Planning Commission Meeting Agenda
Hartland Township Hall
Thursday, April 25, 2024
7:00 PM

Hartland Township Planning Commission Meeting Agenda Memorandum

Subject: Site Plan PD Application #24-003 Redwood Living Planned Development (PD) Phase II – Preliminary PD Site Plan

SCALE: AS SHOWN	DATE: 01/01/24	DRAWN BY: GRAHAM, PE	CHECKED BY: P.FURTAW
PROJECT NUMBER: 23008151	DRAWING NAME: C300 OVERALL GRADING PLAN		
SHEET TITLE: OVERALL GRADING PLAN			
SHEET NUMBER: C300

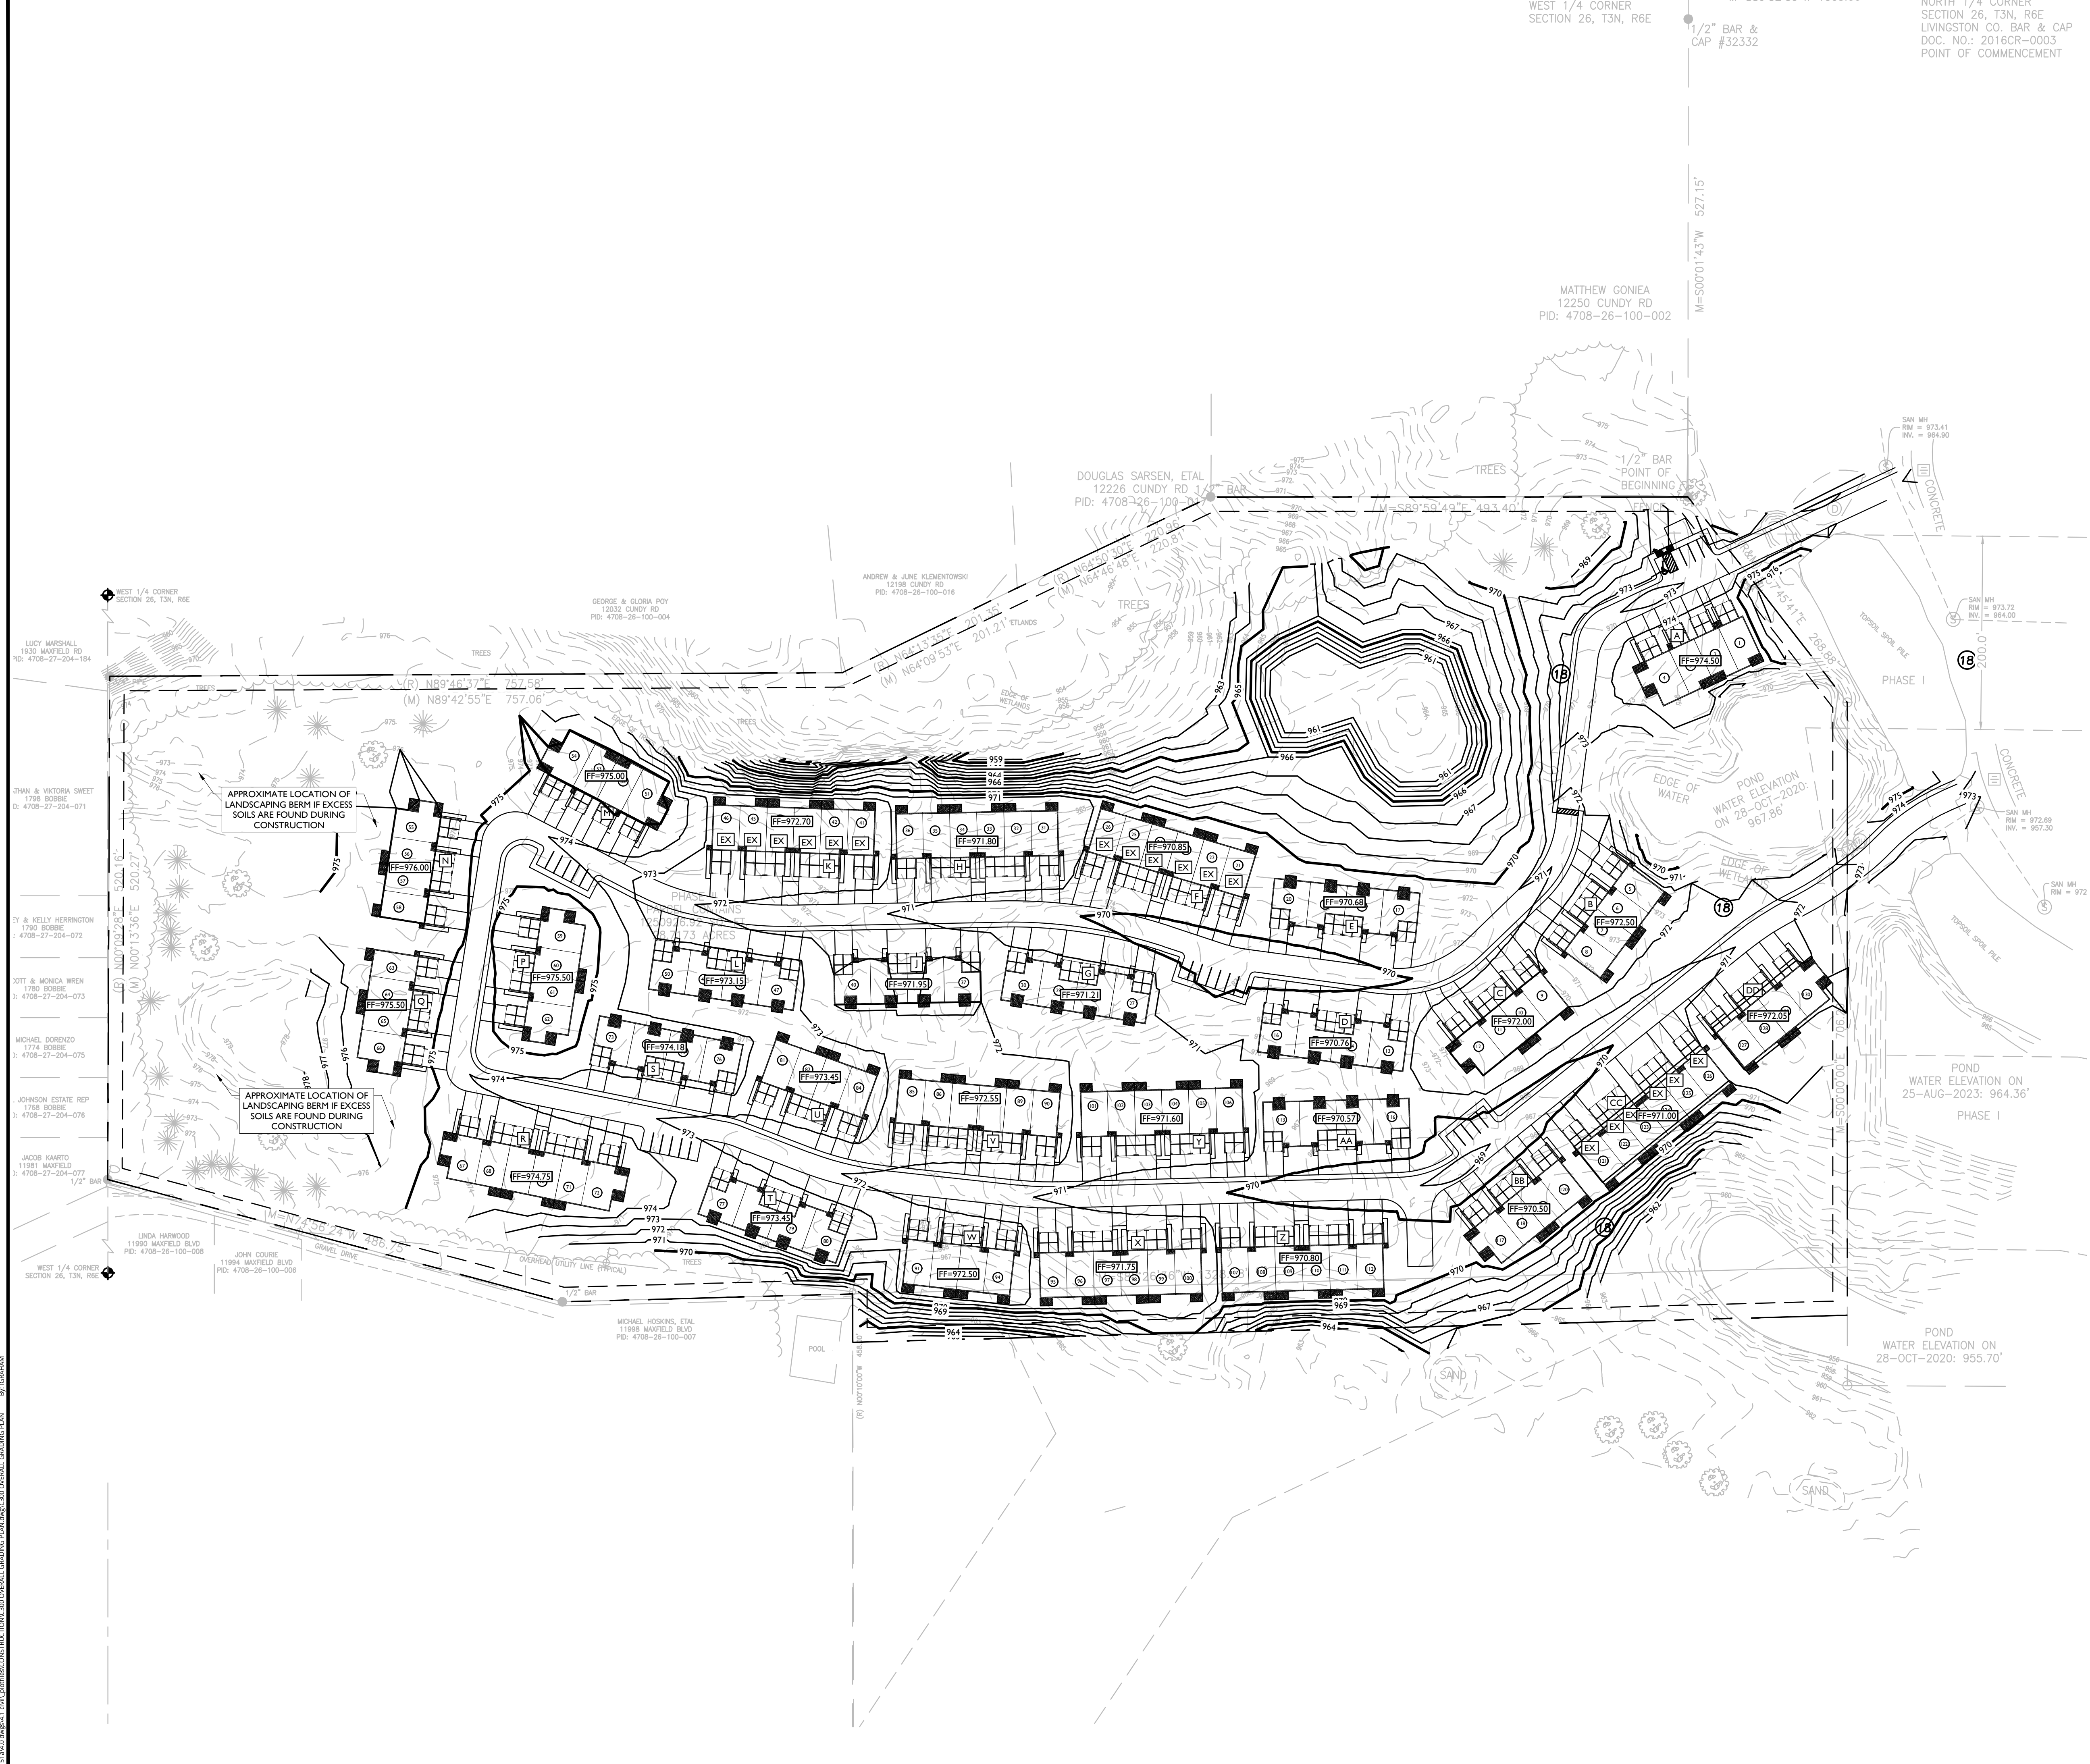
Sheet C300 contains a note in two locations, on the west side of the site, stating “approximate location of landscaping berm if excess soils are found during construction”. Details on the berms and landscape materials were not provided but will be required on the Construction Plan set. Potentially the landscape berms could provide screening on the west side of the development. In the event the berm is not constructed, and excess soil is to be deposited or spread elsewhere (on-site or off-site), the applicant shall provide all applicable details prior to any movement of soil. Should soil be spread near a wetland area, separate reviews, approvals, and permits may be required from the Michigan Department of Environment, Great Lakes, and Energy (EGLE).

1. Drawing C300: Surface water discharging directly to wetlands along north portion of property. All effort shall be made to capture storm runoff and direct to detention area.

10. Drawing C300: Surface water discharging directly to wetlands along north portion of property. All effort shall be made to capture storm runoff and direct to detention area. **Acknowledged. Construction plans will provide more detail on storm drainage.**

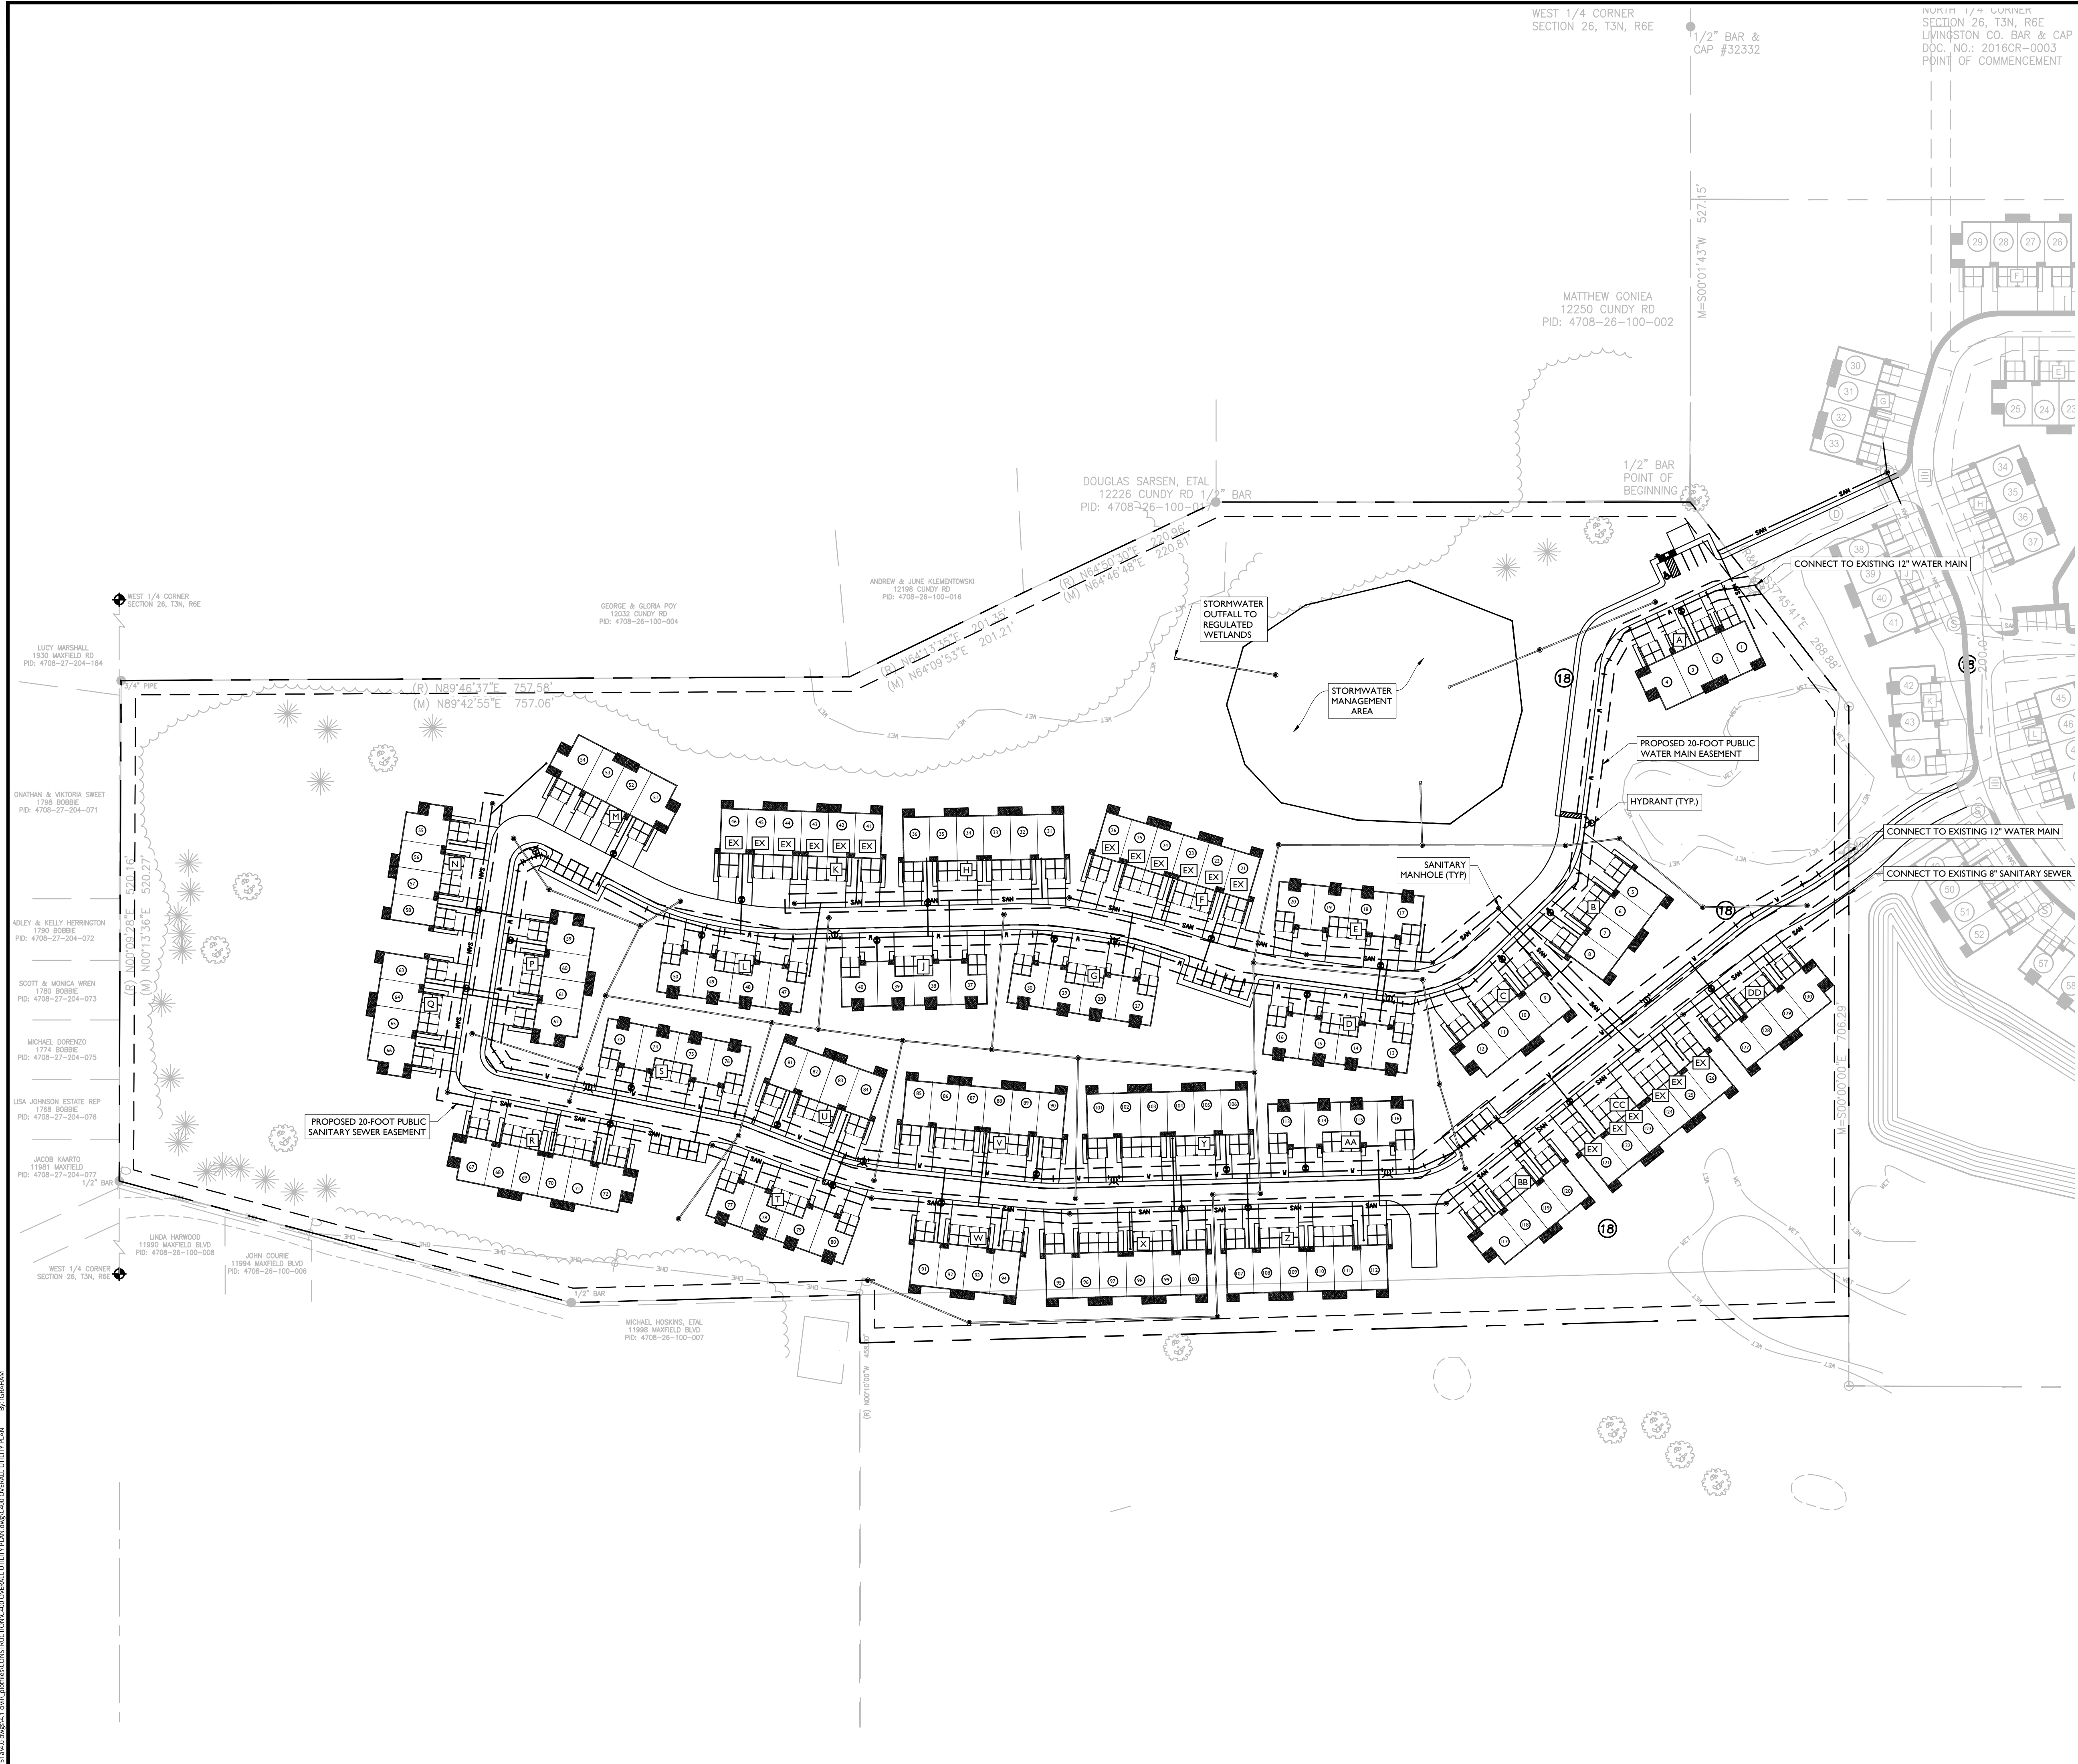
1. Drawing C400: Water main easement shall follow centerline of utility.

1. Drawing C400: Easement missing from sanitary sewer northeast of building A extending into Phase 1.

- c. Drawings must be sealed by a licensed engineer. **Plans will be signed and sealed by a licensed State of Michigan engineer.**
8. Drawing C400: Water main easement shall follow centerline of utility. **Construction plans will provide more detail on easements.**

9. Drawing C400: Easement missing from sanitary sewer northeast of building A extending into Phase 1. **Acknowledged. Construction plans will provide more detail on easements.**
